STAFF REPORT
COMMUNITY DEVELOPMENT DEPARTMENT

SUBJECT: H-2021-0061
 Elsinore Child Care Facility

LOCATION: 4818 & 4858 N. Elsinore Avenue,
 generally located at the northwest corner
 of Meridian Road and McMillan Road.

A. Site Plan (no date) **NOT APPROVED**

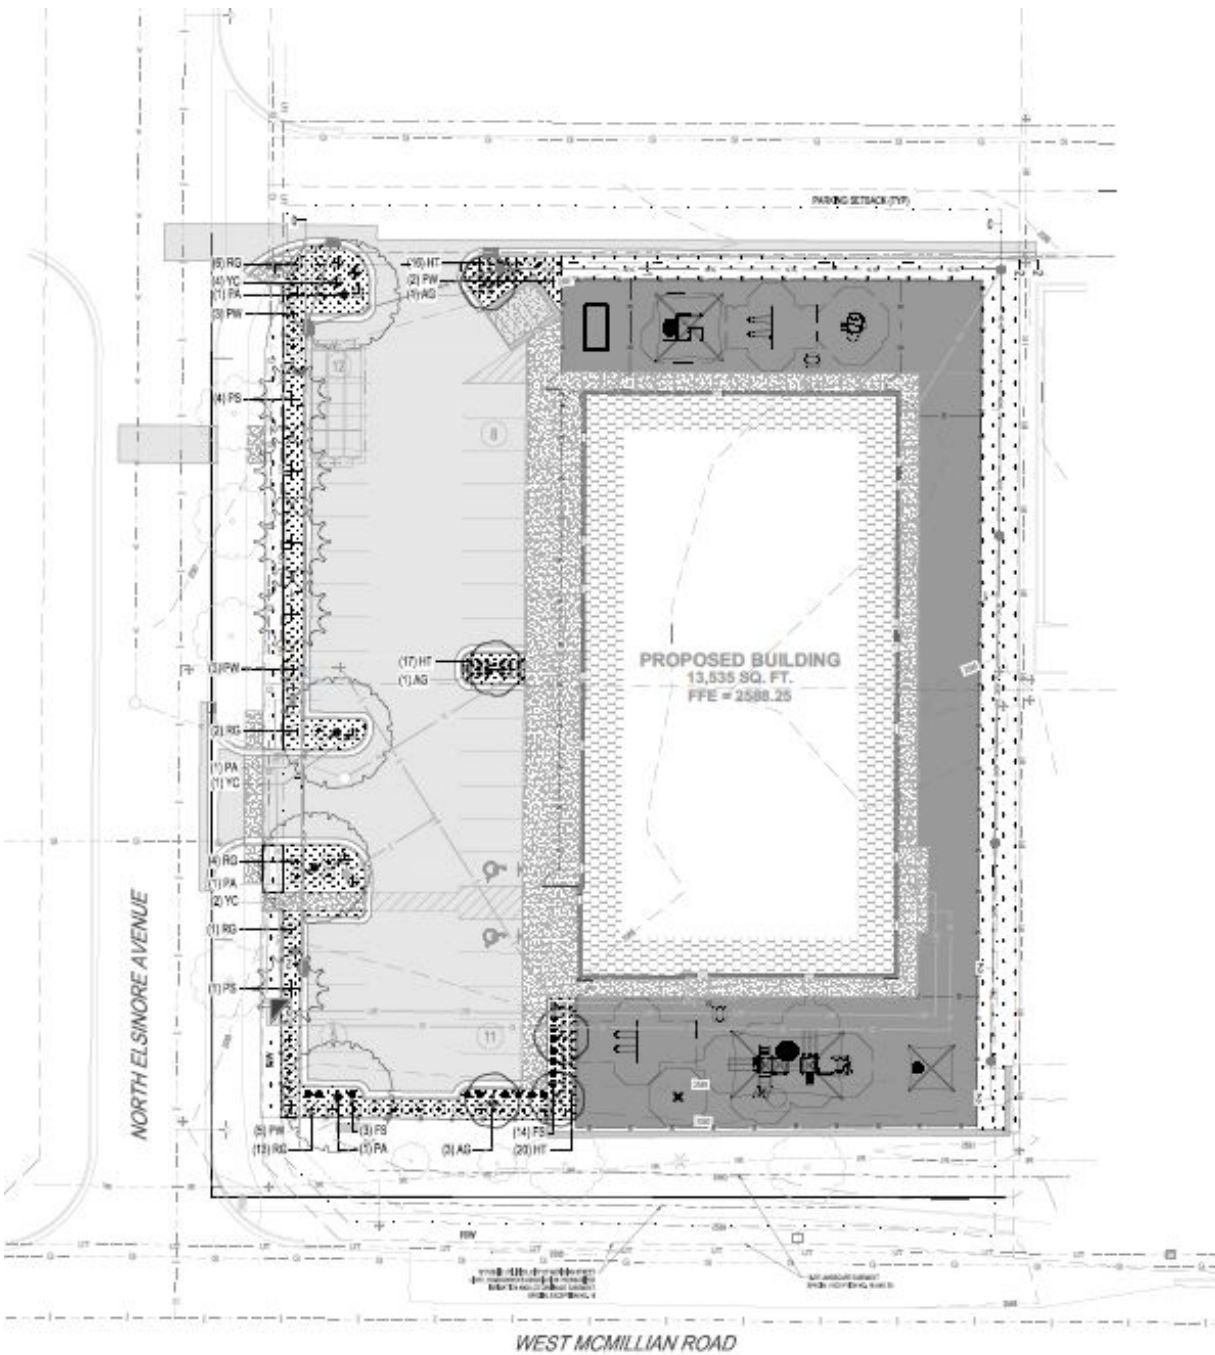
The submitted site plan shows a two-way, 25-foot wide drive aisle along the west side of the building with parking on both sides to equal 36 total parking spaces. The building is shown as approximately 13,500 square feet requiring a minimum of 27 parking spaces per code requirements for nonresidential uses (1 space/500 square feet). Therefore, the Applicant is proposing parking in excess of code requirements. However, the site plan does not show any dedicated pick-up/drop-off location other than the parking spaces. The Applicant is proposing two points of ingress/egress for the subject site; one access to Elsinore Avenue to the west and one access to the north to the existing shared drive aisle that runs east-west through the commercial development. The inclusion of two access points for the parking area provides more than one avenue for parents to access the site.

In addition, ACHD is requiring a dedicated westbound right-turn lane and a dedicated eastbound left-turn lane to Elsinore Avenue from McMillan Road. With these dedicated turn lanes and multiple ways to access the subject site, some of Staff's concerns regarding access are mitigated. However, Staff does have concerns the proposed parking drive aisle could be overrun at peak pick-up/drop-off hours in the morning and afternoon with the current site design. During discussions with the Applicant, it has been noted the daycare operator prefers parents to park to discharge and pick-up their children instead of simply a quick stop-and-go drop-off. To help mitigate this concern, Staff recommends a reduction in building size to allow for additional parking along the north end of the site, similar to what exists within this commercial development to the east. See below:

If a similar sized parking area is included on this site, approximately an additional 10 parking spaces should be able to be added to the site to total 46 with this recommendation. Staff does not anticipate the play area along the north boundary being reduced with the inclusion of additional parking because the building itself should be reduced in size, nothing else. Staff has recommended a condition of approval commensurate with this option.

UDC requires that new commercial buildings provide 5-foot wide sidewalks from all public entrances to the arterial sidewalks. The submitted plans show one such connection via striping across the drive aisle and a small segment of sidewalk to the sidewalk along Elsinore; no other sidewalk connections to the existing sidewalk network are proposed. Per [UDC 11-3A-19B.4b](#), pedestrian facilities that traverse vehicle use areas (including drive aisles and parking lots) shall be constructed in a material different from the driving surface to clearly separate the pedestrian facility from the driving surface—painted striping does not satisfy this requirement. Therefore, Staff is recommending a condition of approval to revise the site plan to show any pedestrian facility that crosses a driving surface be constructed with stamped or colored concrete, brick pavers, or similar to meet this code requirement.

Code requires an additional connection to the sidewalk along McMillan Road, an arterial street, and the most logical and feasible place for this to occur is by continuing the sidewalk south along the front of the building and connect to the McMillan sidewalk within the existing landscape buffer. In addition, with Staff's recommended changes to the north end of the site to add parking

Staff is recommending the site plan and landscape plan are corrected at the time of CZC submittal to show the required sidewalk connections and any revisions to the site plan.

3. Minimum separation between the water main and building must be 10 feet, which is currently not met on the south end of the building.
4. Maintain a minimum of 4 feet separation from water main lines from the UE line.

6. The site plan and landscape plan shall be revised as follows prior to the Commission Hearing:
 - a. ~~Revise the site plan to show a reduced building size to accommodate additional parking at the north boundary of the site adjacent to the shared drive aisle similar to what exists to the east.~~

- b. In accord with UDC 11-3A-19B.4, show any pedestrian facility that crosses a driving surface be constructed with stamped or colored concrete, brick pavers, or similar;

- c. ~~Add a sidewalk connection from the site to the existing sidewalk along W. McMillan Road in accord with UDC 11-3A-19B.4;~~
 - d. Revise the type of fencing proposed around the perimeter of all play areas to be non-scalable per the specific use standards listed in UDC 11-4-3-9 (*i.e. wrought iron fencing or vertical steel tube fencing*);

- f. Include the turn lanes required by ACHD from W. McMillan Road to N. Elsinore Avenue—an eastbound center left turn lane and a westbound right turn lane; prior to Certificate of Occupancy for the building, the Applicant shall provide proof to the Planning Division that these turn lanes have been constructed per ACHD requirements.

B. Landscape Plan (no date) **NOT APPROVED**

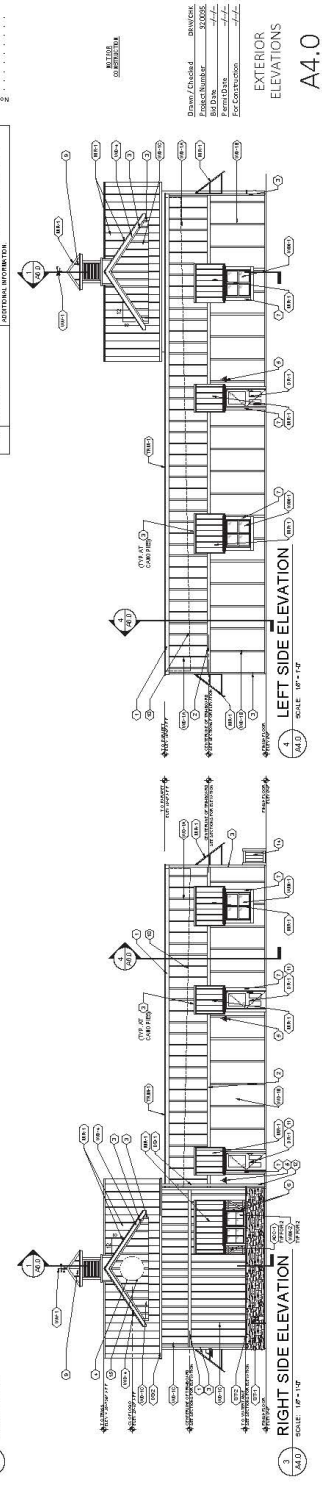
1. All outdoor play areas shall be completely enclosed by minimum six foot (6') non-scalable fences to secure against exit/entry by small children and to screen abutting properties. *The submitted landscape plans show a 6' vinyl coated chainlink fence along the perimeter of the play areas which surround the building on the north, east, and south sides. Chainlink fencing does not qualify as non-scalable fencing so the Applicant is required to revise the fencing material. Staff is recommending a condition of approval to provide fencing consistent with code requirements (i.e. wrought iron fencing or vertical steel tube fencing).*
The outdoor play area may be reduced in size as a secondary consequence of requiring more parking or a discharge/pick-up area along the north boundary of the site. However, Staff is also recommending the building size be reduced which should not inherently require the outdoor play areas also be reduced.

The project requires a 25-foot landscape buffer to McMillan Road, an arterial street, and a 10-foot buffer to Elsinore Avenue, a local street, per C-G dimensional standards in UDC Table 11-2B-3. Both of these required buffers are already existing and contain the detached sidewalk. However, the submitted landscape plans do not show the existing buffers and landscaping and this should be corrected with future plan revisions to ensure the adequate buffer width is maintained. Staff's recommendations to revise the site plan to accommodate more parking should not alter any landscaping requirements. In addition, the requirement to construct a right turn lane onto Elsinore Avenue should also not affect the existing buffer because there is adequate space for this. Should this not be true, the Applicant is required to maintain the minimum 25-foot buffer width. All other landscaping proposed is for the parking lot landscaping and appears to meet UDC standards.

- e. Show the existing and required street buffers along N. Elsinore and W. McMillan. The existing landscaping shall be protected during construction in accord with UDC 11-3B-10;
